Subject ▶ Change on crank housing

For Models ▶ HM1500 and HM1500B (Demolition Hammer)

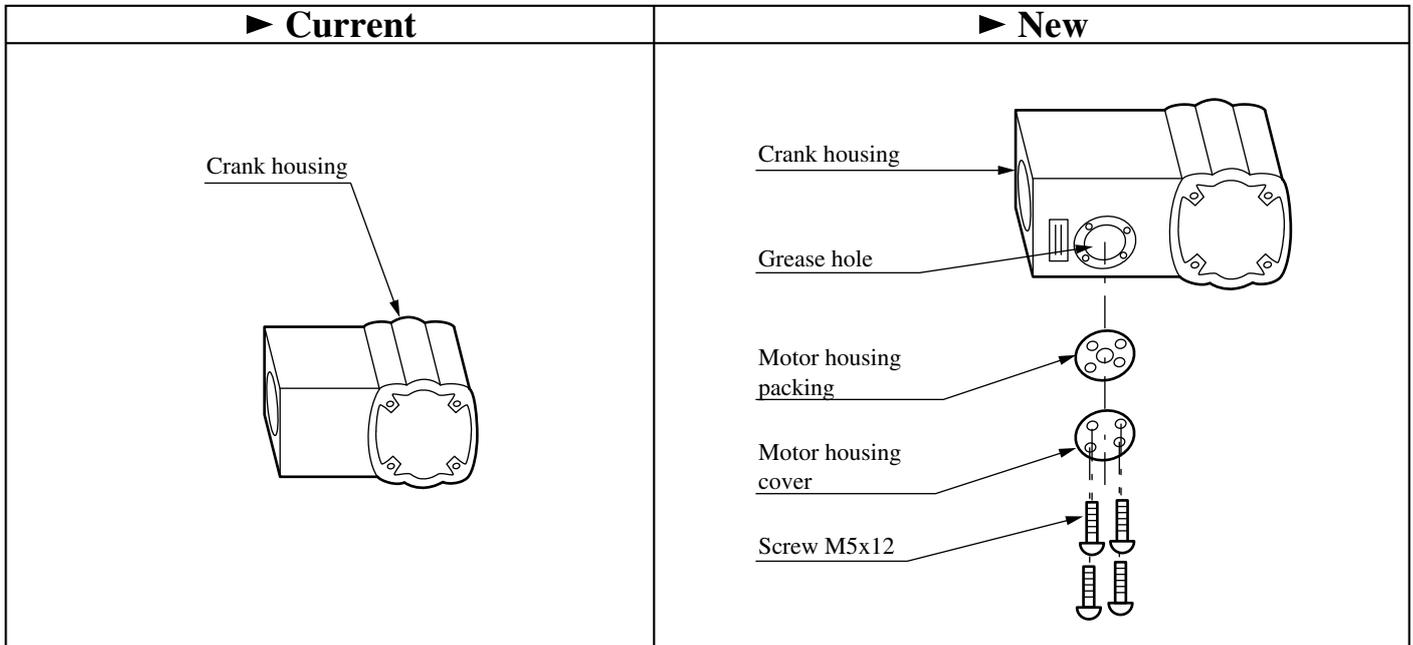
Description ▶ A grease hole will be made in the crank housing as shown below.

The current type part (crank housing) and the new type parts (crank housing, motor housing packing, motor housing cover and screw M5x12) are interchangeable as a set.
